UNITED STATES ENVIRONMENTAL PROTECTION AGENCY

Re: Notice of Deficiency
March 18, 2018 RCRA Facility Investigation Work Plan
Maple Street Commerce, 101 E. Maple, North Canton, Ohio
OHD 004 462 131

Figure 2: West Factory, New AOCs and Relative Soil Gas Results

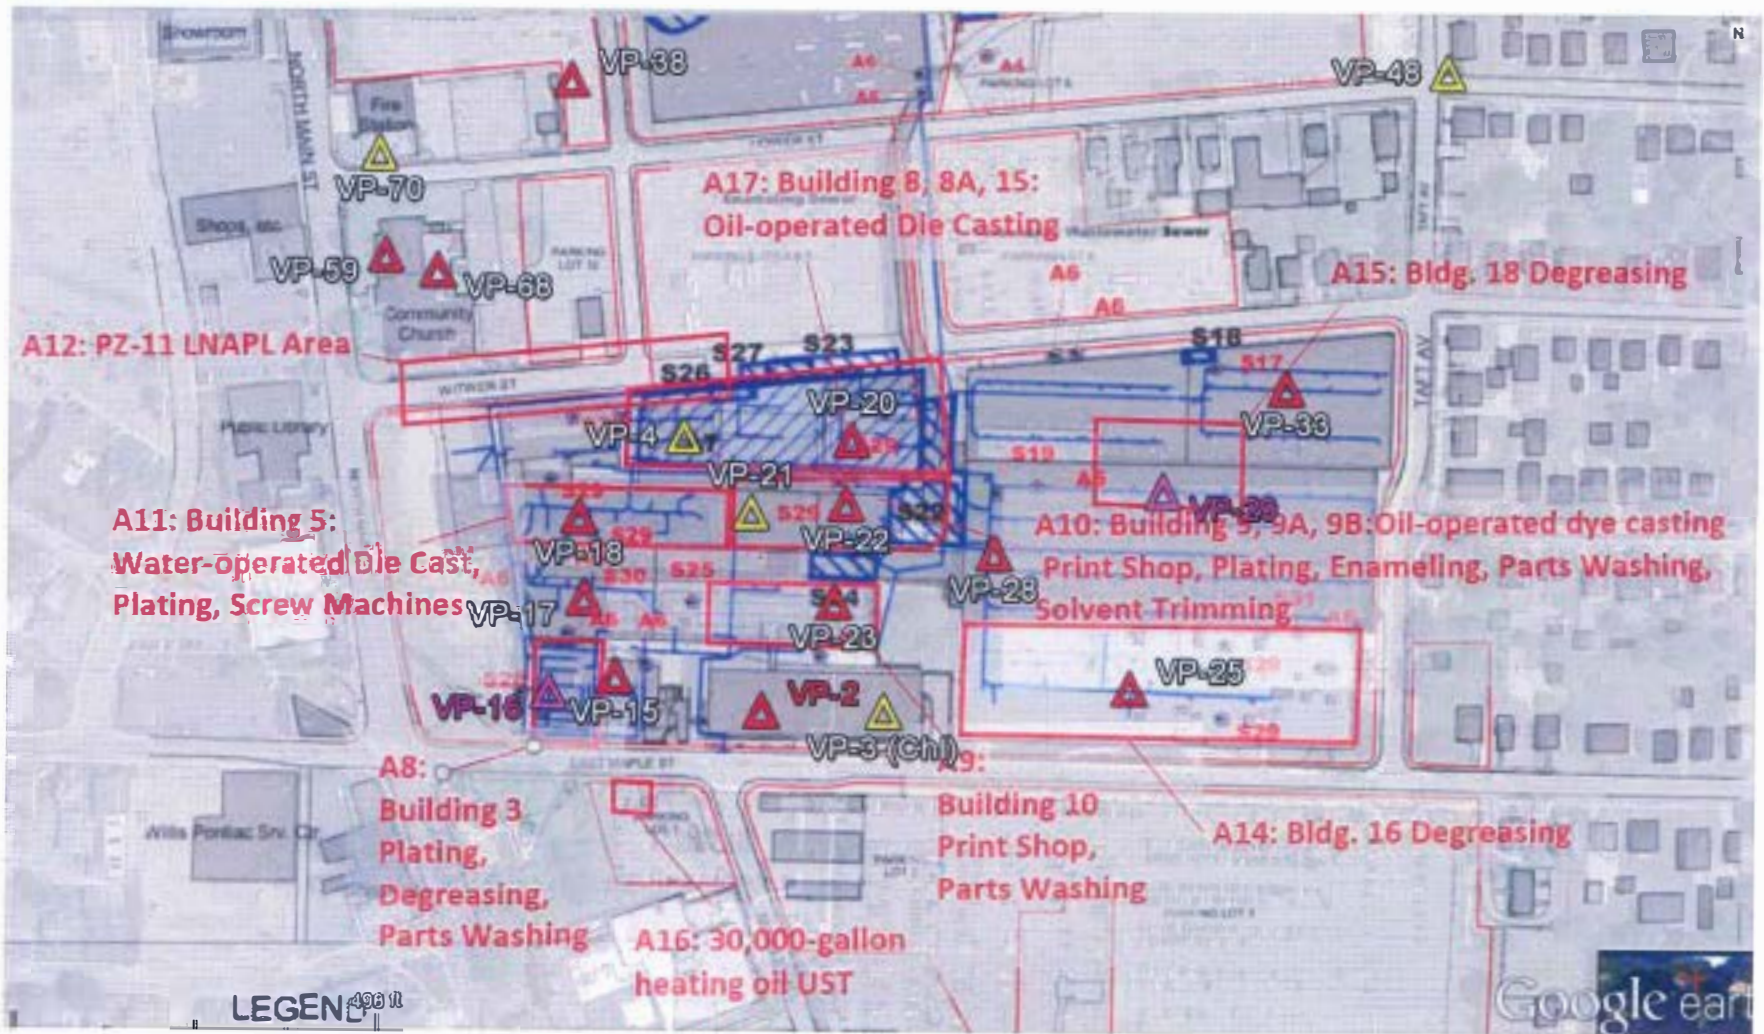
- 2) The Work Plan must include limited soil sampling in areas that exhibited elevated subslab VOC concentrations (VP-2, VP-15, VP-17, VP-18, VP-20, and VP-22), to identify the magnitude of possible underlying source areas and evaluate risk. VOCs were detected at significantly elevated subslab vapor concentrations where VOCs were not reasonably anticipated to be contaminants of concern (COCs) associated with the related SWMU. These newly identified VOC impacts are areas that require investigation under the 2016 AOC. Paragraph 15.b. of that AOC requires sampling locations to include, among other things, areas where screening criteria were exceeded and areas where the potential exists for the volatilization of contaminants from soil and groundwater to indoor air. The Work Plan should also add these VOC-impacted areas to the list of areas of concern. EPA considers these locations new/potential areas of concern; results confirmed these areas, which MSC targeted for subslab and indoor air sampling, were impacted; and EPA previously suggested MSC include them in the list, and anticipated MSC would update the Current Conditions Report to identify them as new areas of concern based on the data MSC collected. I enclose a list of the areas EPA proposes MSC add to the list of areas of concern, along with a figure that superimposes them on soil gas/air results from those buildings. An investigation will help evaluate source concentrations and potential active remedies, particularly in the west factory. EPA's future selection of a proposed remedy will rely on balancing criteria that includes the degree to which a remedy employs treatment that reduces the toxicity, mobility, or volume of hazardous waste and hazardous constituents.

- 4) The Work Plan must relocate HSB-142 to the area south of the center of Building 11, and HSB-143 to the area due south of VP-25. This will help assess potential for contaminant migration along the bedrock surface in these areas and provide information about unidentified sources of subslab VOC contamination nearby, beneath Buildings 11 and 16.

- 6) The Work Plan needs to collect more information on the source of soil gas contamination at VP-40 and VP-41. MSC can make further attempts to locate MW-17D and sample MW-17D and PZ-17D; or install MIP/HSB borings near VP-40 and VP-41 and analyze confirmation soil/groundwater samples to further evaluate the TCE contamination found in these vapor pin samples. Until more information is gathered, MSC must continue monitoring VP-40 and VP-41 on a quarterly basis due to the proximity of adjacent residences and past TCE levels of 18 parts per million at SB-128. MSC needs to investigate whether the current/recent groundwater monitoring at shallow depths misses groundwater migration that may be present at deeper intervals, since the source of contamination found in soil gas in this area has not been definitively identified.
